April 4, 2022

RE: Docket Number EERE-2017-BT-STD-0017: Proposed Rule for Energy Conservation Standards for Dehumidifying Direct-Expansion Dedicated Outdoor Air Systems

Figure 1. Deviation of tested ISMRE value from ASHRAE 90.1 minimum ISMRE versus percent difference between tested ISMRE and ISMRE2 values for the sample units.⁴

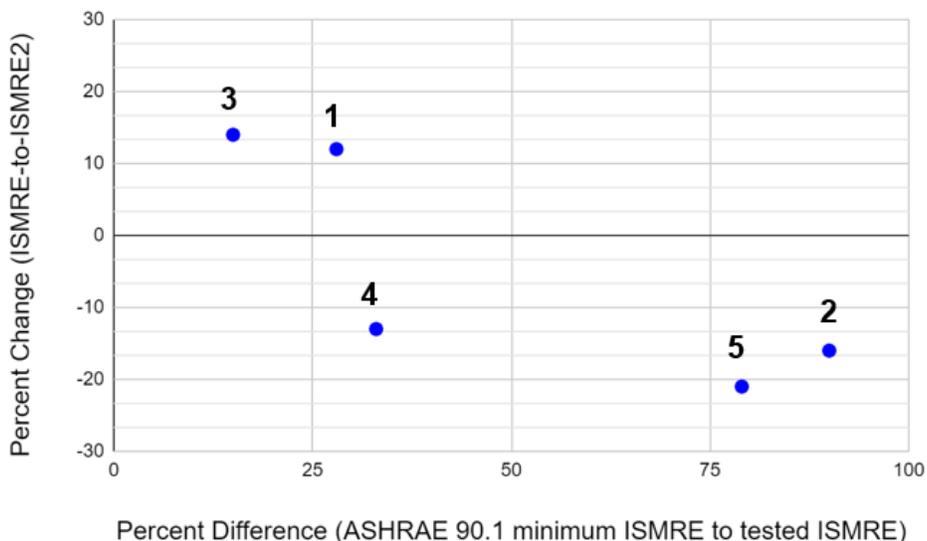
We suggest that DOE instead determine the crosswalk based on the performance of the units that are closest to ‘minimally compliant’: samples 1, 3, and 4 in Figure 1.³ With this approach, the crosswalk would be 4% instead of -5% (i.e., the ISMRE2 would be 4% *higher* than ISMRE instead of the 5% *lower* proposed in the NOPR).

³We note that in the crosswalk analysis for IS COP to IS COP2, DOE modeled ‘minimally compliant’ models whose deviation from ASHRAE 90.1 minimum IS COP ranged from -4 to 9%. The ISMRE deviation for samples 1, 3, and 4 are 28%, 15%, and 33%, respectively. These are still above baseline, but more representative of models on the margins of compliance with minimum standards.
